# Baldwin County Planning & Zoning Commission Agenda

Thursday, July 10, 2025
4:00 p.m.
Baldwin County Central Annex
Main Auditorium
22251 Palmer Street
Robertsdale, Alabama
Email:planning@baldwincountyal.gov

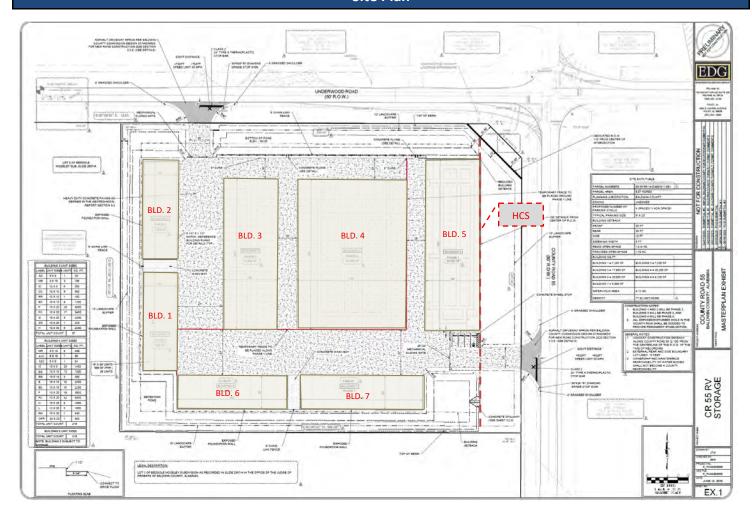
- 1. Add vicinity map to site plan
- 2. Show a 10' Landscape buffer along Underwood Rd.

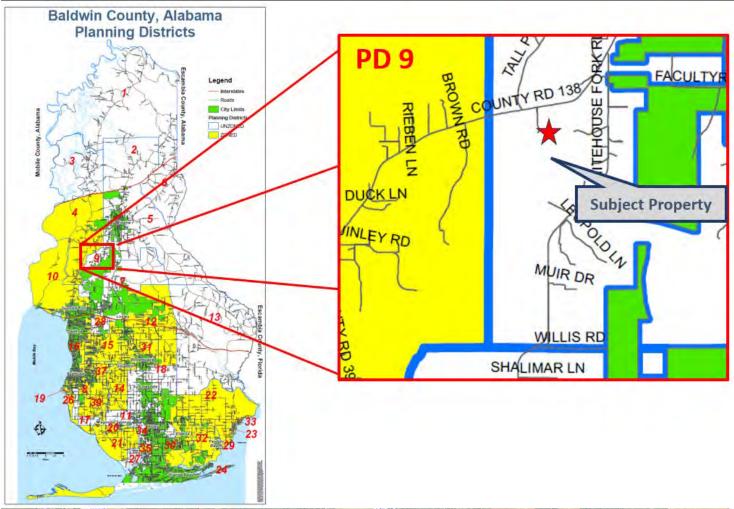
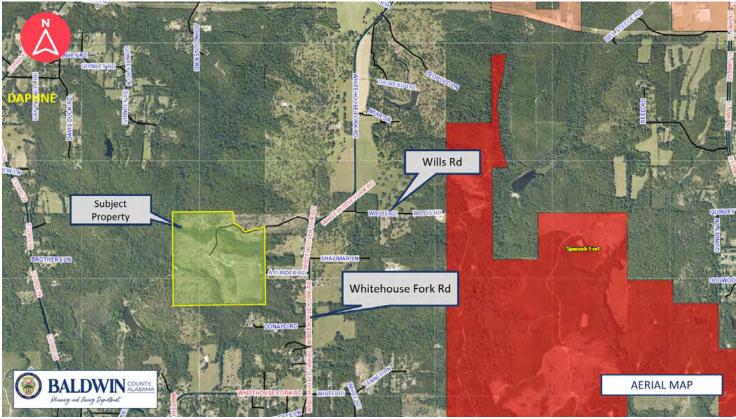
1. Provide a clean plat without the clouded revisions.

### Section 6.1.3(c.)1(ii)

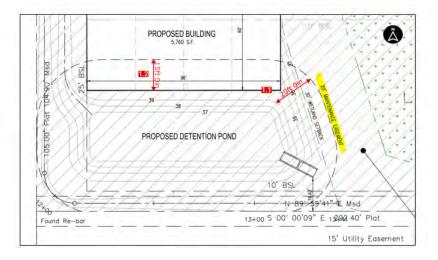
The proposed building encroaches approximately **15 feet** into the required 20-foot maintenance easement for the proposed detention pond. A reduction of the maintenance easement **along the north side** is requested.

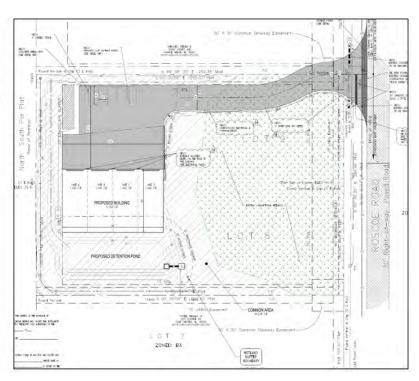
The proposed bioswale that will be utilized for stormwater purposes will be located within the required 30' landscape buffer located along the southern property line. As a result of the abundant wetlands on the property, the bioswale cannot be relocated to an alternate location, therefore the applicant is requesting an elimination of the 30' landscape buffer requirement along the southern property line for placement of the bioswale.

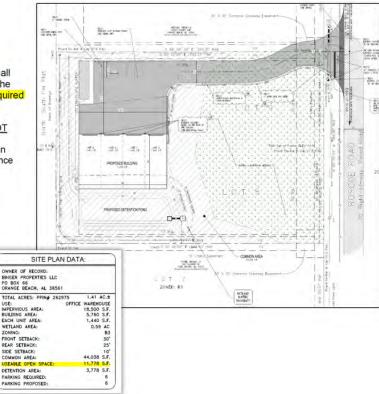
Useable open space, such as parks, recreational facilities or pedestrian paths are not common with mini-storage facilities. Furthermore, the jurisdictional wetlands on the property would prevent the site from meeting the useable open space requirement.

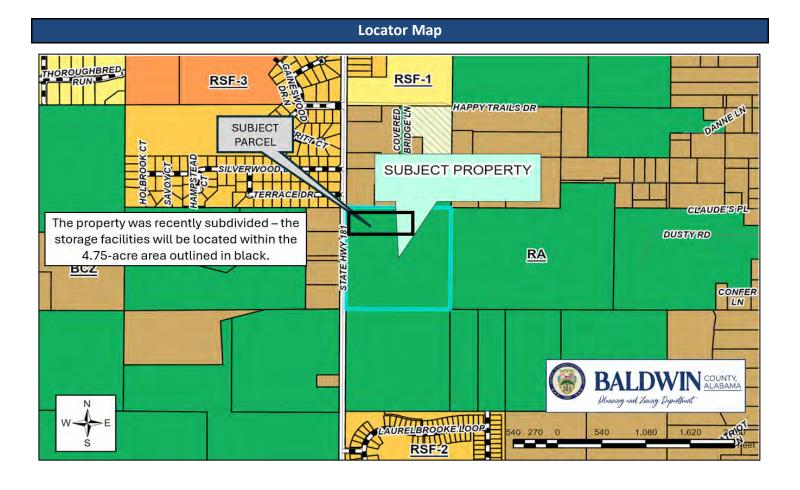
Per applicant: "The detention/retention facility for this project is located within a portion of the required 30' landscape buffer on the south and east sides of the property. The size of the retention/detention facility needed to accommodate the Good Neighbor Stormwater Policy and meet water quantity requirements for reduction of post-development discharge rates to lower than or equal to pre-development discharge rates requires utilization of portions of the landscape buffer. This is due to the topography in this area of the parcel and the area required to match the existing grades at the boundary of the parcel."
